# FINAL PLAT OF HANLEY SECOND ADDITION

## AN ADDITION TO WICHITA, SEDGWICK COUNTY, KANSAS

Re: S/D 98-5 -- One-Step Final Plat of HANLEY 2ND ADDITION

CASE NUMBER: S/D 98-5 - HANLEY 2ND ADDITION

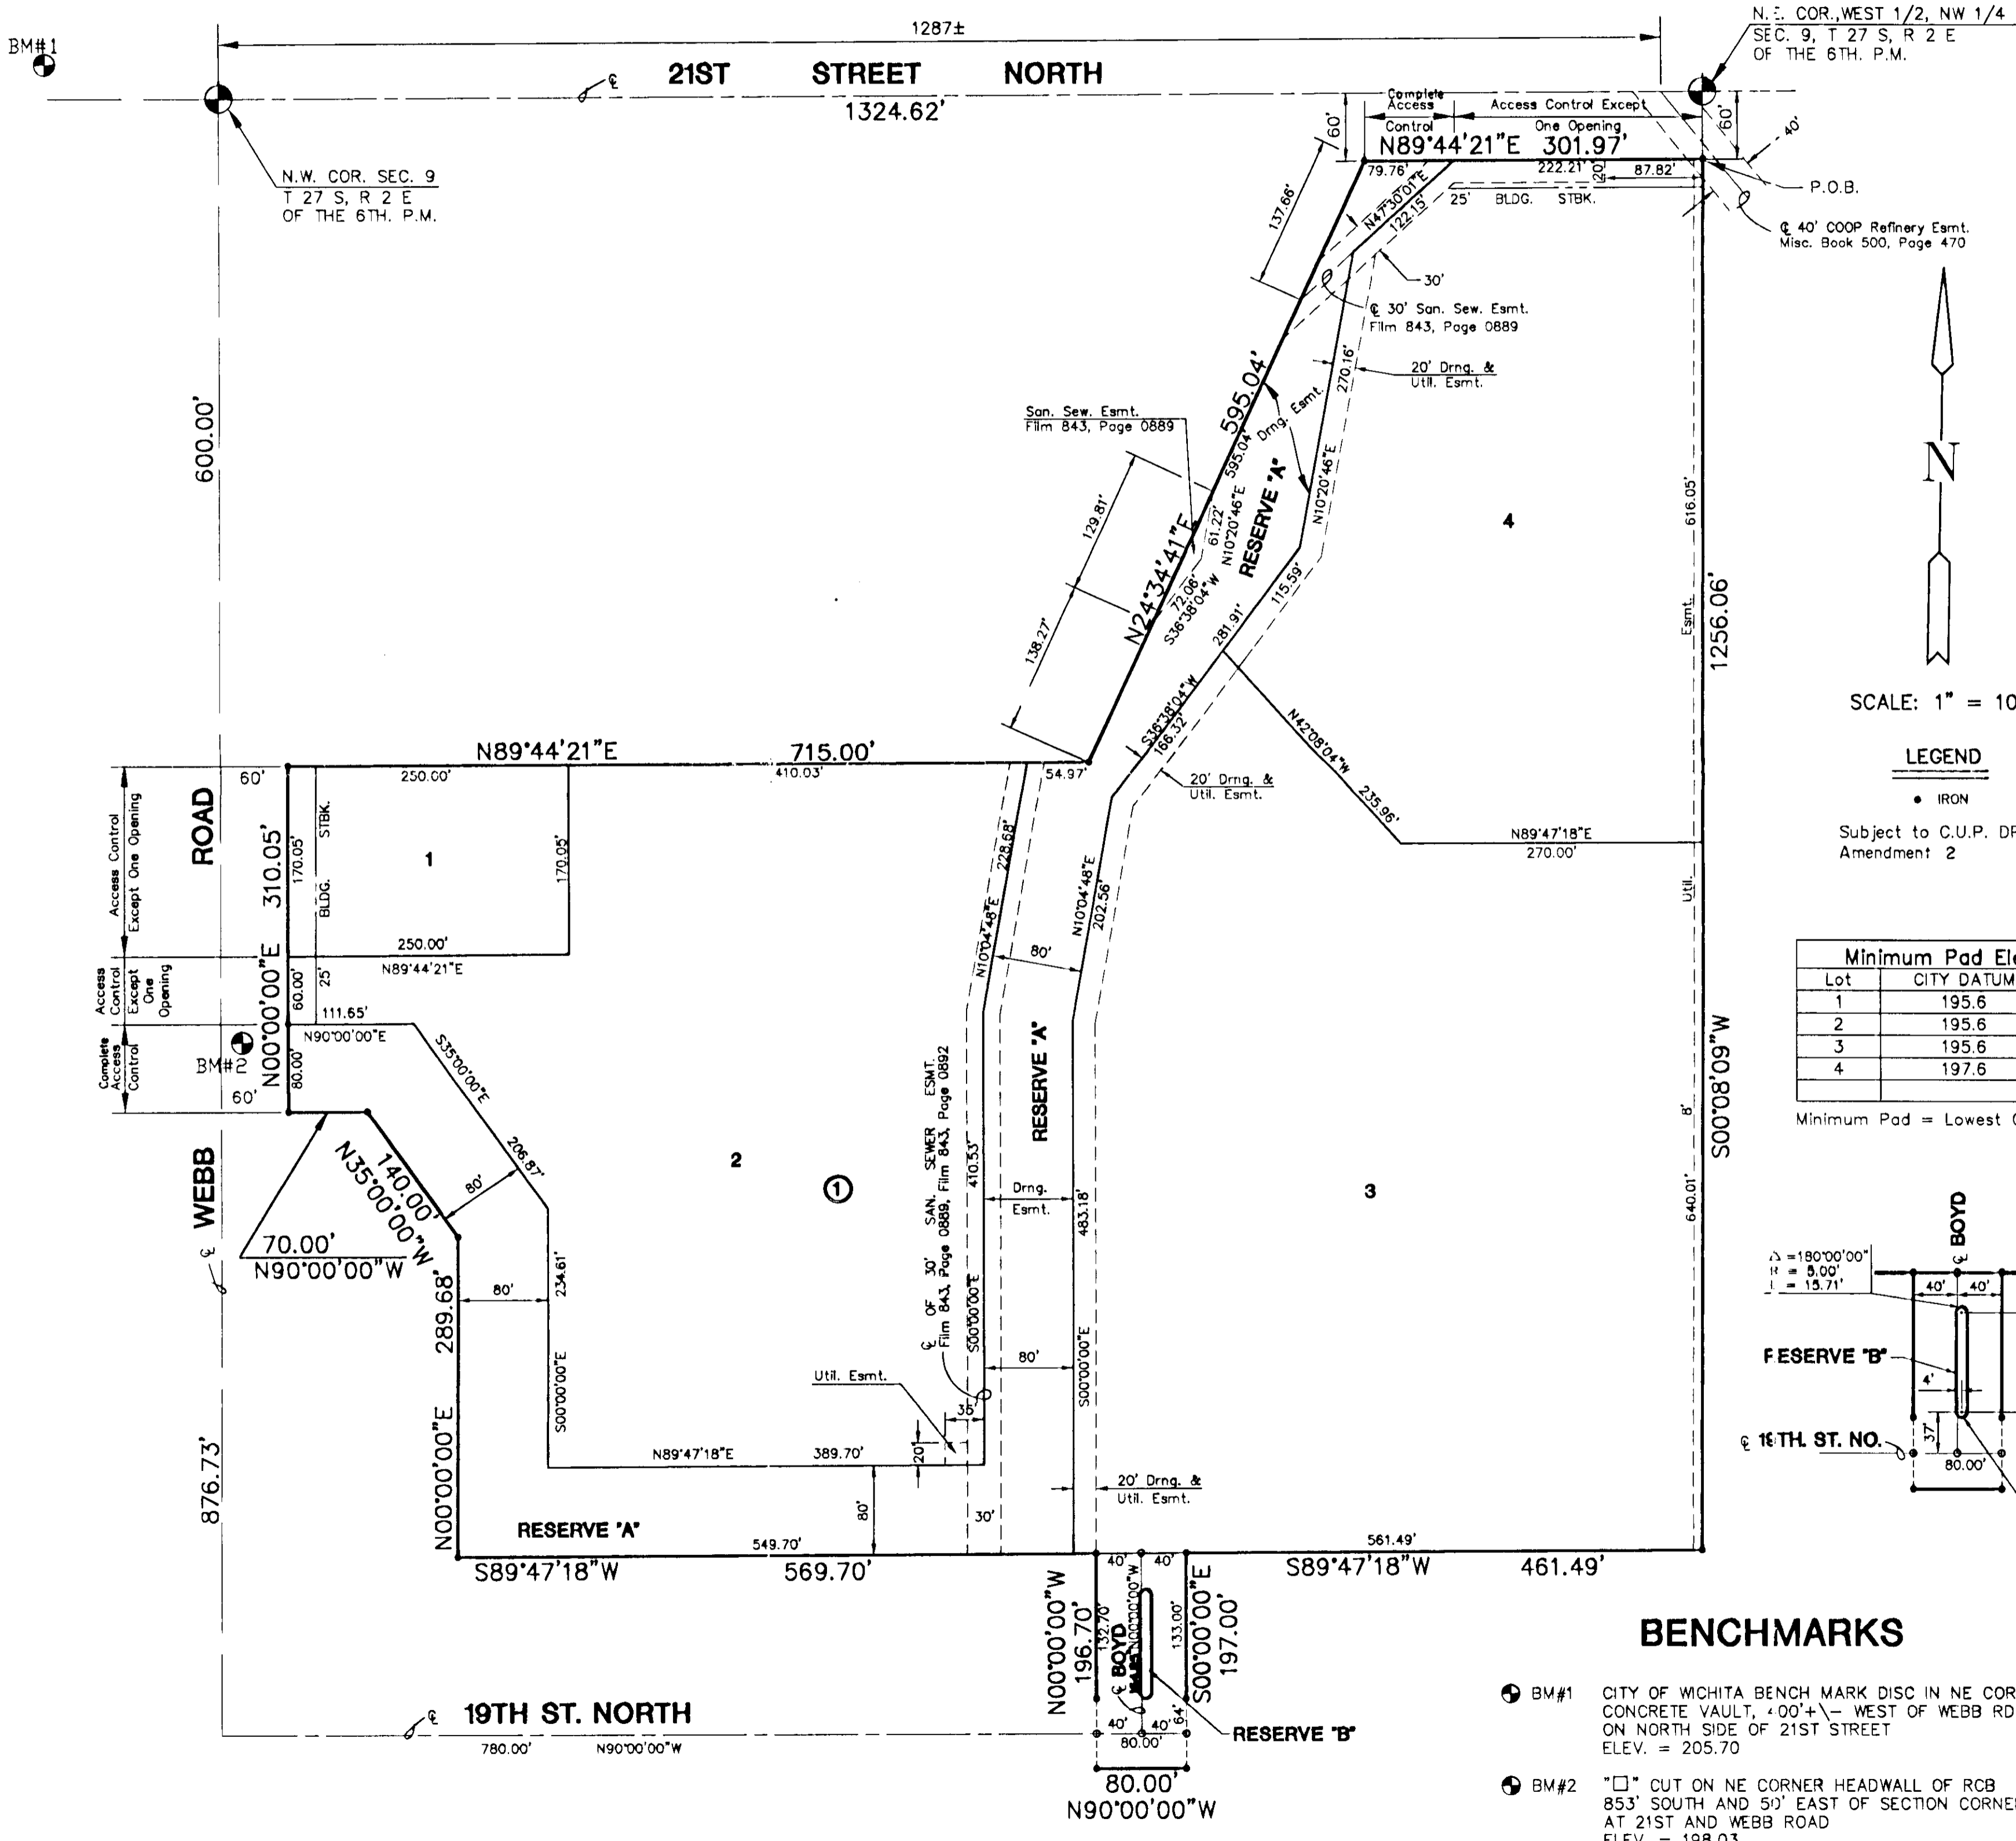
- E. **Traffic Engineering** needs to comment on the acceptability of the access controls. The plat denotes two openings from Webb Road and one opening from 21st Street North. This does not correspond with the CUP, which denoted one opening from Webb Road. Approval of this

variation would require an adjustment to the CUP. Traffic Engineering has approved the access controls. One additional opening along Webb Road was permitted for this plat due a reduction of one opening north of this site.

Applicant has indicated a public street will be constructed. The final plat tracing shall denote said dedication of right-of-way and a petition shall be submitted guaranteeing paving.

- G. ✓ The final plat tracing should indicate that this plat is subject to DP-154 Amendment 2.
- H. ✓ The legal description in the platting binder (dated 1995) does not correspond with the land being platted. An updated platting binder should be submitted indicating current outstanding property taxes and easements.

- I. ✓ The legal description in the plattor's text needs to be revised to include the northern line of the plat.
- J. ✓ A 25-foot front yard setback from 19th Street North shall be denoted on Lot 3.

- K. ✓ A surveyor's signature line needs to be added on the final plat tracing.
- L. ✓ The MAPC Chair needs to be revised to read Richard E. Lopez.
- M. ✓ The language "complete access control" should be replaced with "access control" where openings are indicated.

- N. ✓ The centerlines of Webb Road and 21st Street North should be indicated by "CL".
- O. ✓ The applicant shall submit an avigational easement covering all of the subject plat and a restrictive covenant assuring that adequate construction methods will be used to minimize the effects of noise pollution in the habitable structures constructed on subject property.
